Display AFY240320B0-2.4N6NTM-R

veronica.chen@orientdisplay.com <veronica.chen@orientdisplay.com> 19 de noviembre de 2024, 18:01
Para: walter@pirri.com.ar
Cc: Bill Cheung <bill@orientdisplay.com>

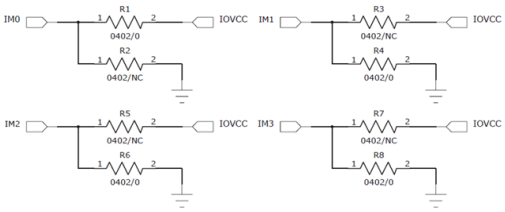
The default interface is a 16-bit MCU. If you want to change it to an 8-bit MCU, it can be done by modifying the resistor values on the FPC.

The current resistor values on the FPC are as shown in the image below.

[IM3, IM0] = 0 (R8=0Ω, R7=NC), 0 (R6=0Ω, R5=NC), 0 (R4=0Ω, R3=NC), 1 (R2=NC, R1=0Ω)

To change to 8-bit MCU. Please set resistor value as below.

[IM3, IM0] = 0 (R8=0Ω, R7=NC), 0 (R6=0Ω, R5=NC), 0 (R4=0Ω, R3=NC), 0 (R2=0Ω, R1=NC)
